CROWN STREET WOLLONGONG

RTS DESIGN RESPONSE
WOLLONGONG DEVELOPMENTS NO.8 PTY LTD

RtS DESIGN RESPONSE PURPOSE

DPHI-3

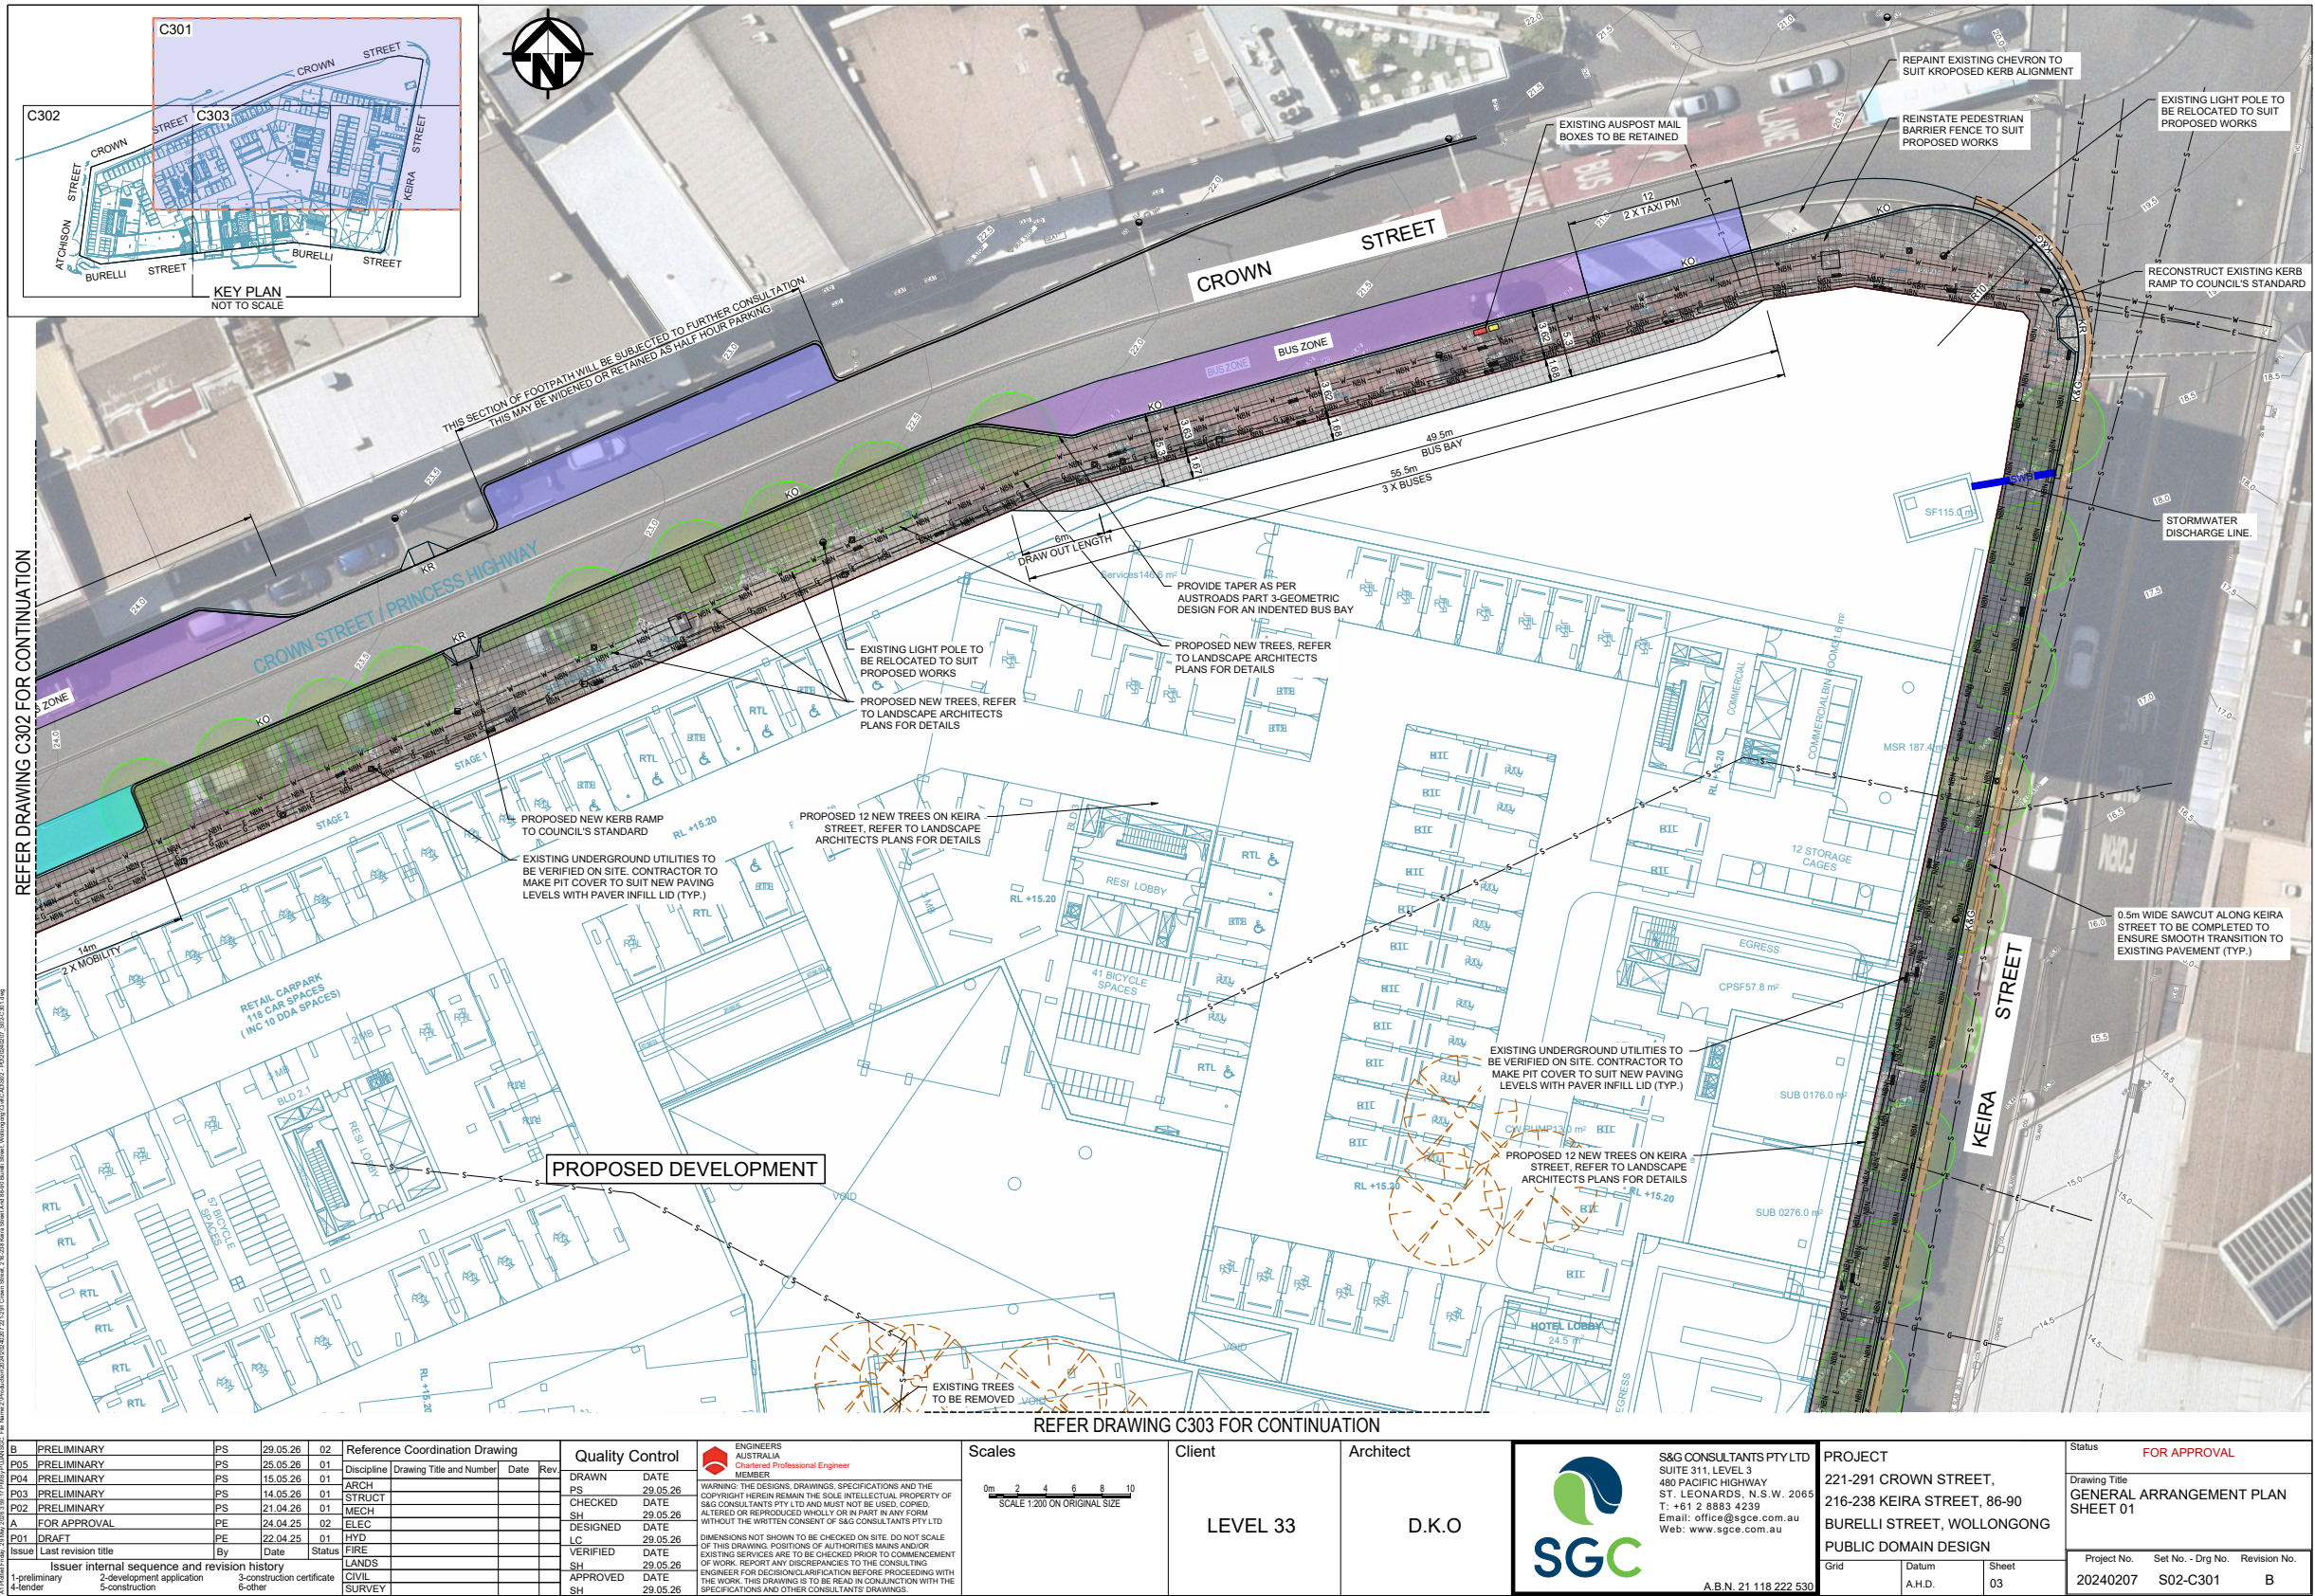
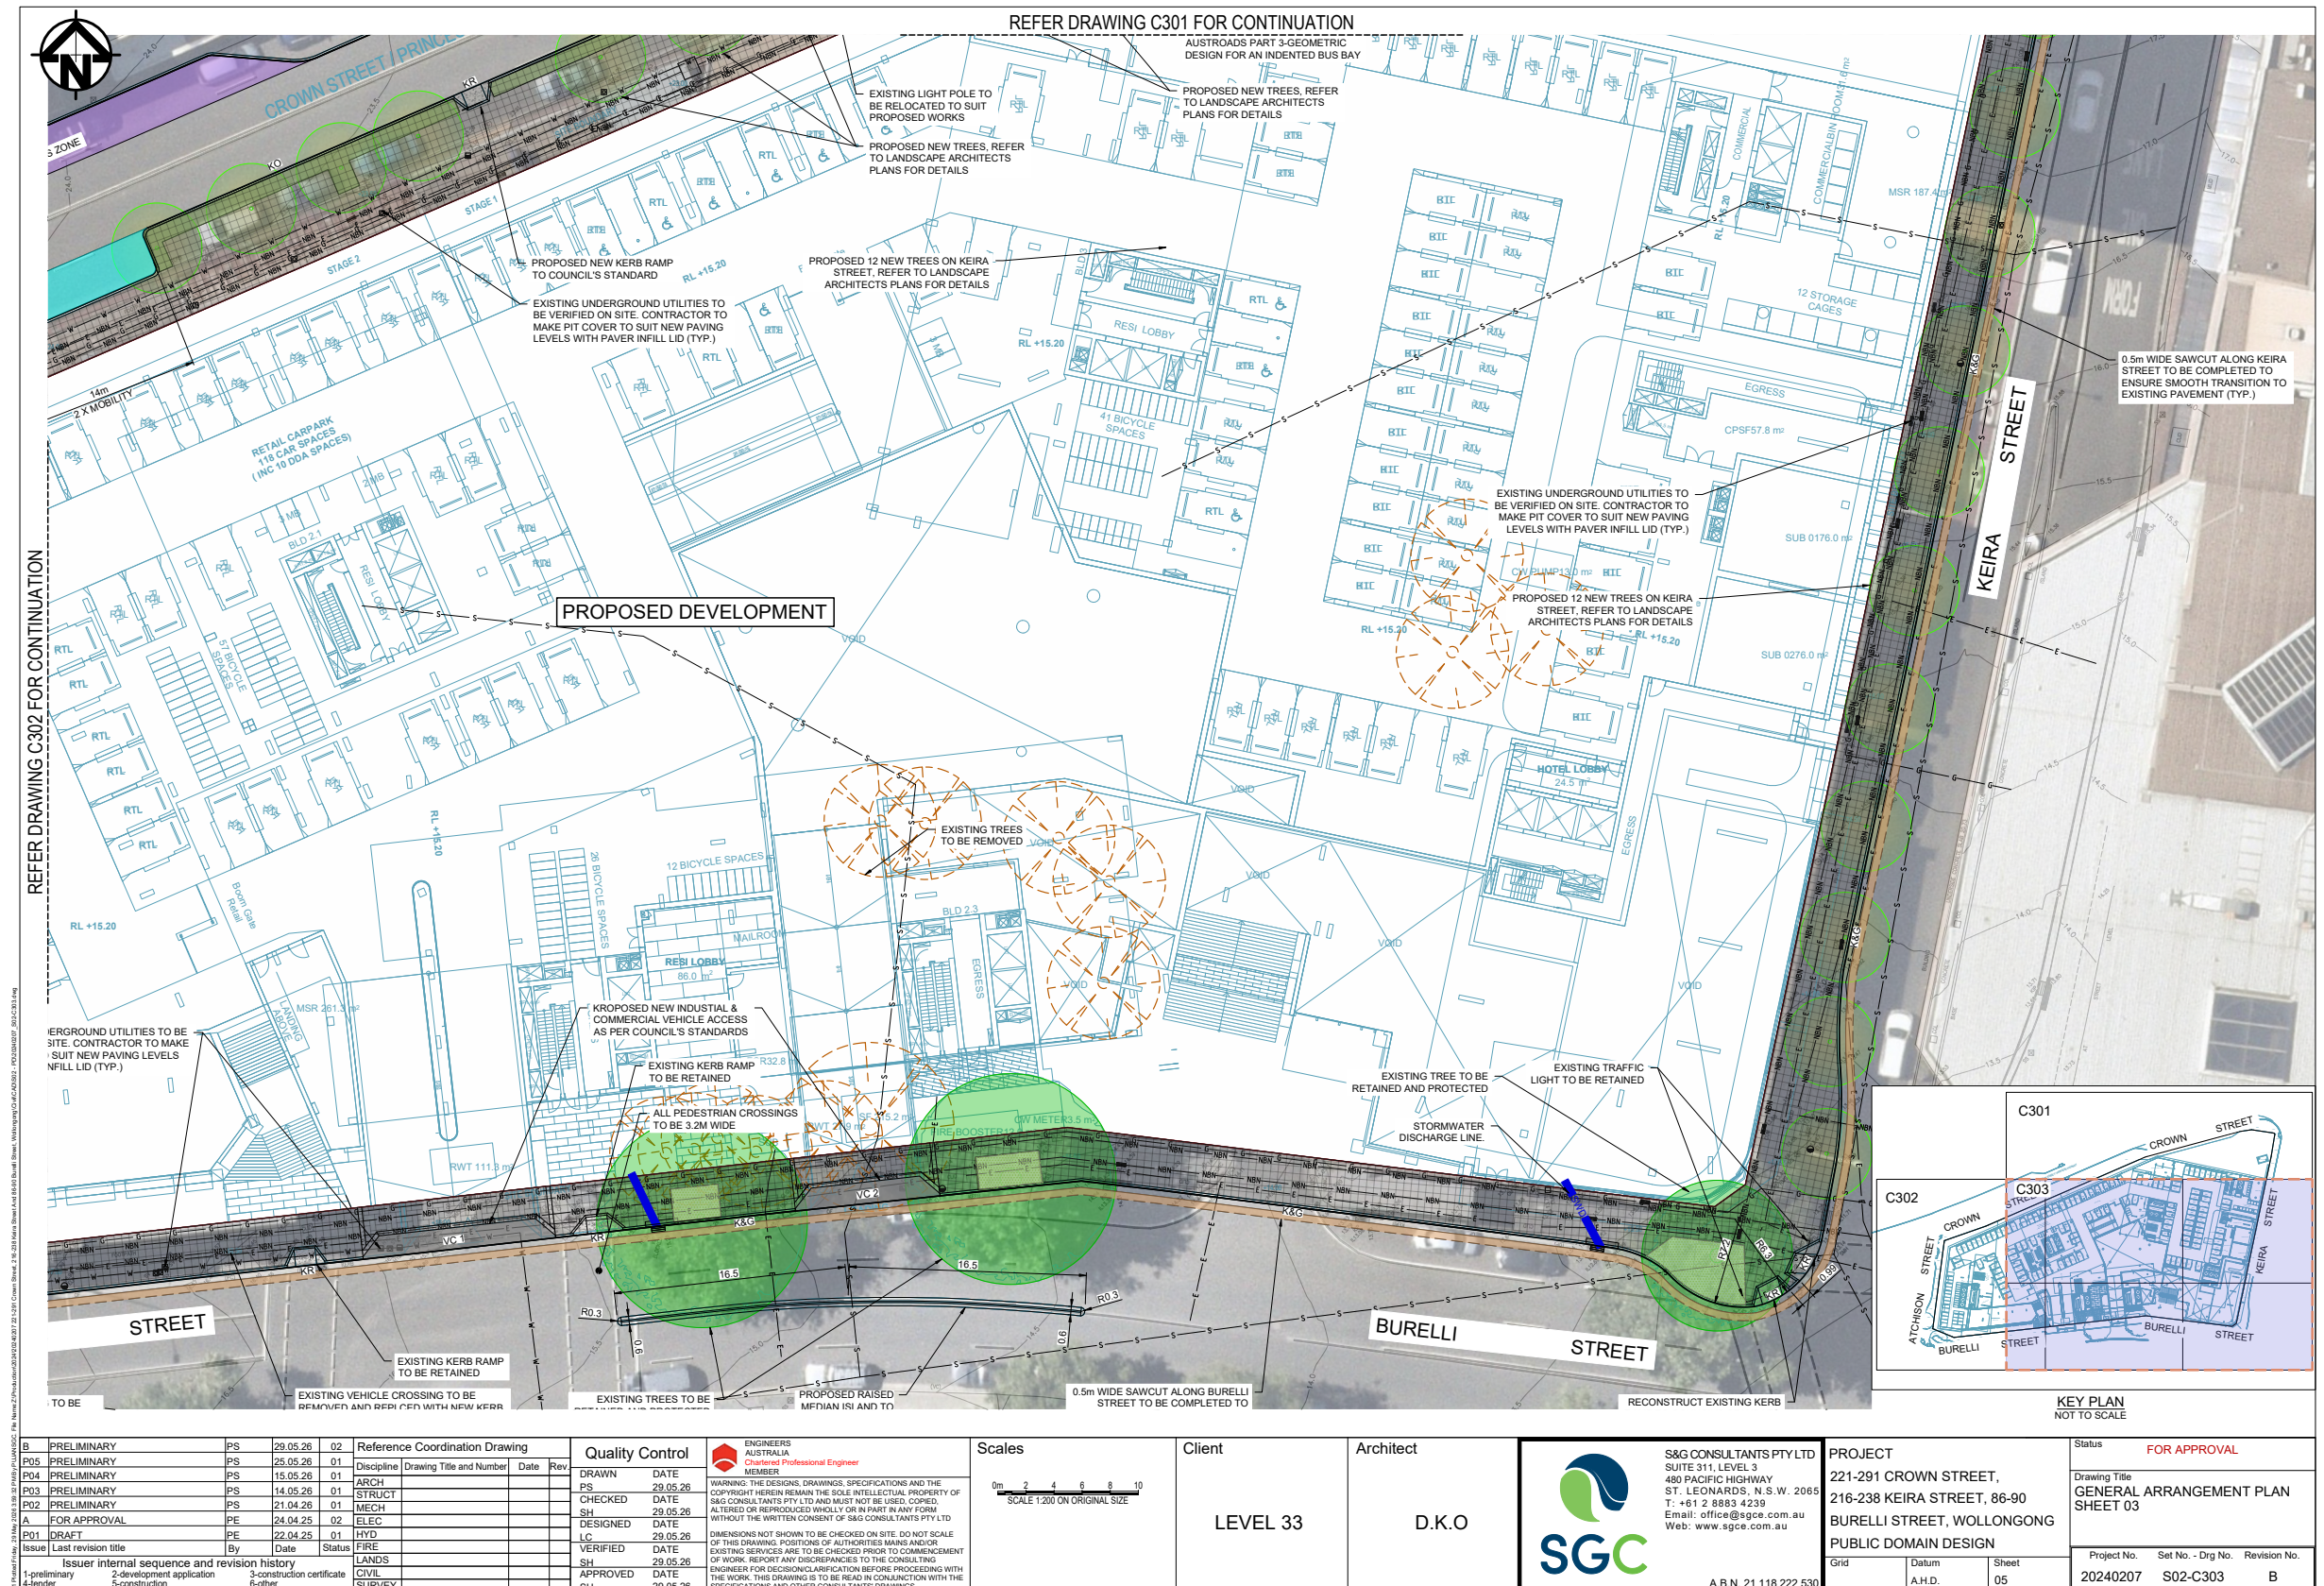
- Provide civil drawings and an updated public domain plan that clearly detail the works required by both Council and TfNSW including:
 - the removal of the slip lane on Atchinson Street and signalisation of the intersection

- the redesign of Crown Street to the satisfaction of TfNSW, including the works to accommodate the bus stop relocation and widened kerb alignment on both sides of the street,

- the works required on Keira Street including any changes to the kerb alignment
 - the works on Burelli street to accommodate the site access including signalisation of the intersection, removal of crossings and preventing right turns into the site

- swept path diagrams for any relevant vehicles including buses and include details of any regulatory signage and the location of all necessary street infrastructure.

- Ensure all landscape and architectural plans are updated to be consistent with revised public domain plans .

EAST-WEST THOROUGH SITE LINK

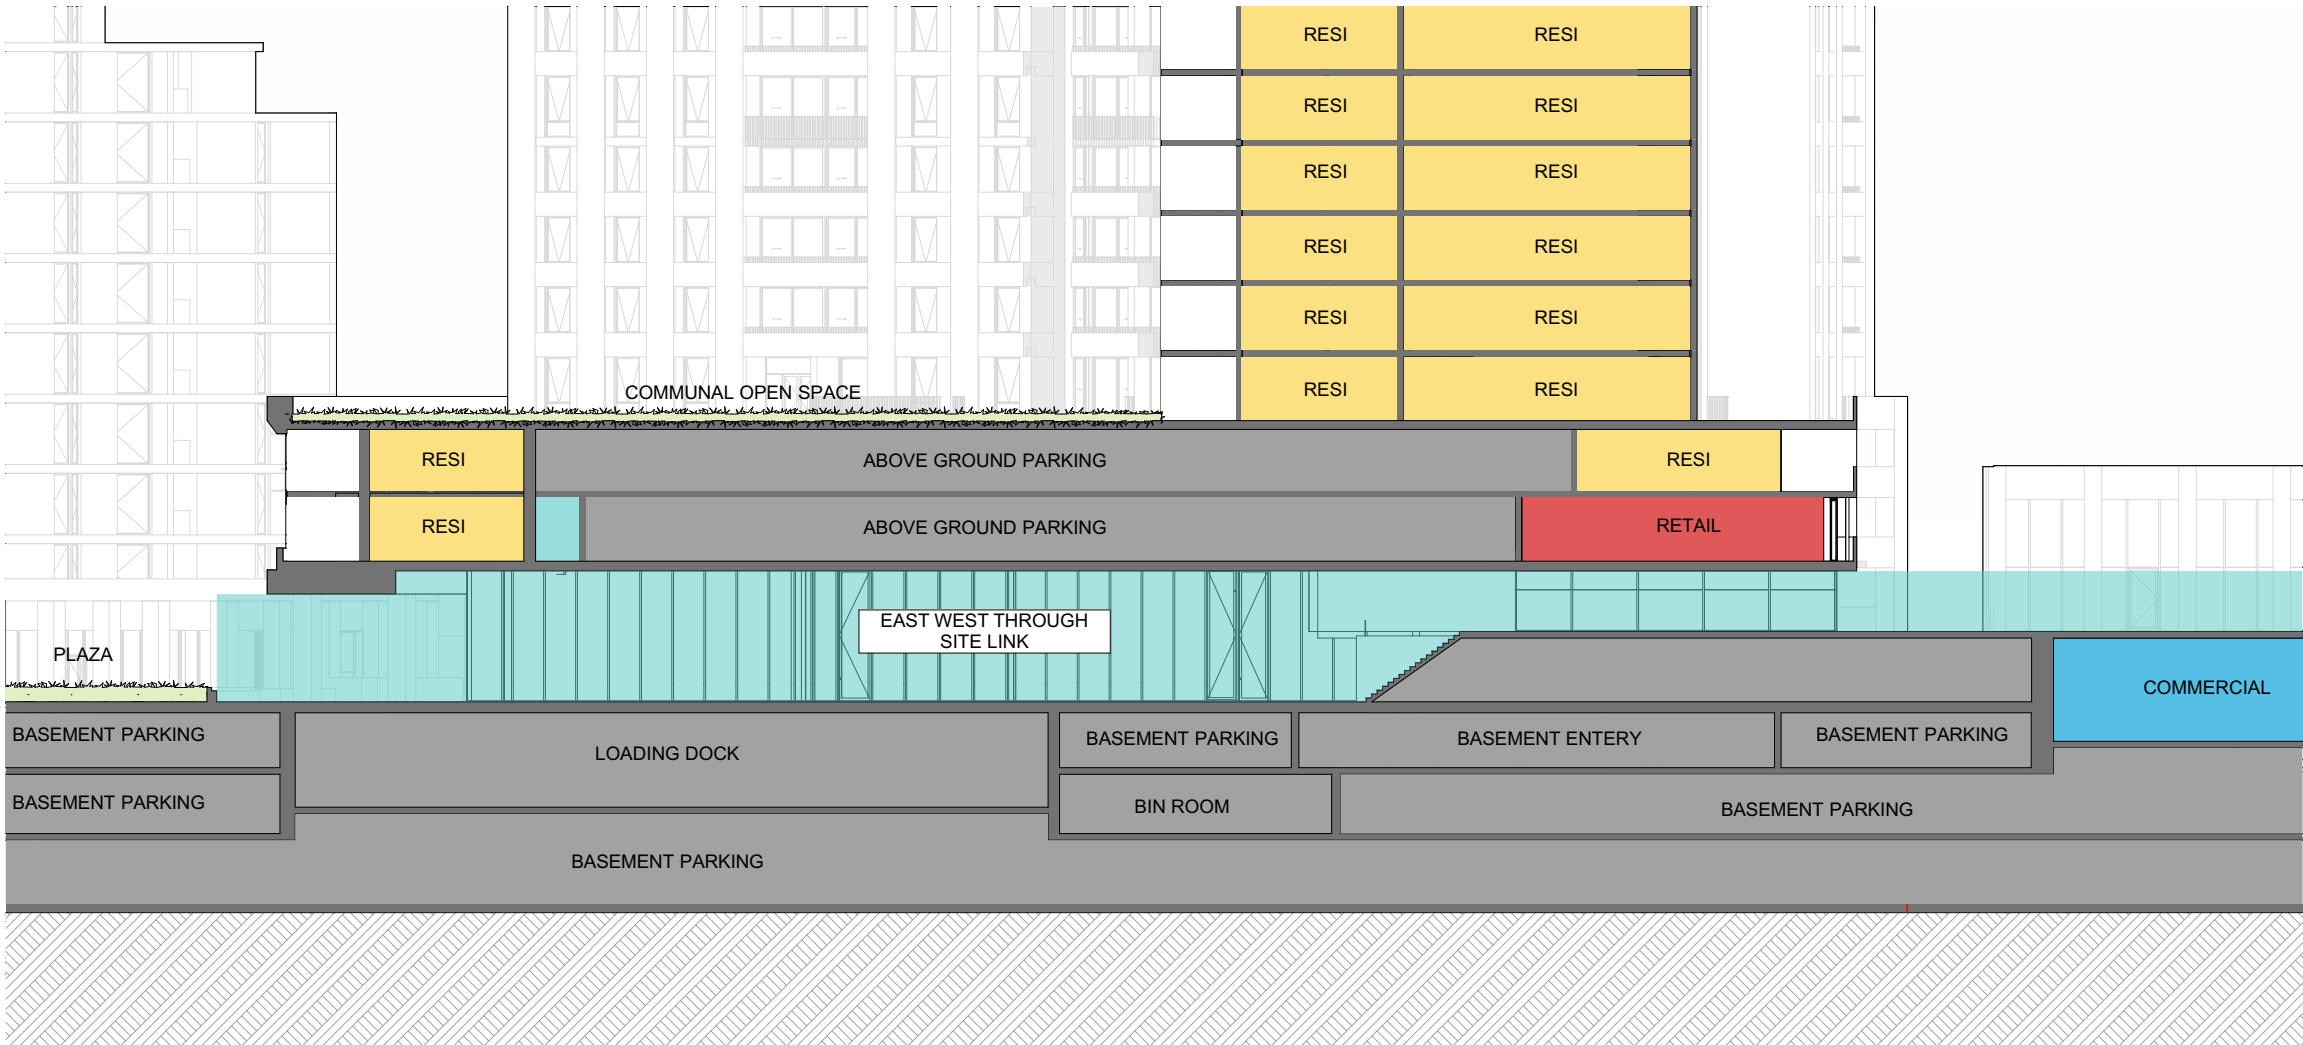
Consider options to enhance east-west permeability through the podium by providing a connection/additional entry from the supermarket to the western through site link, as well as a connection from the Marcus Clarke building's large retail tenancy to both the western lane way and Atchison Street.

Response
A new east-west through-site link has been incorporated into the plans to improve pedestrian permeability and connectivity across the site.
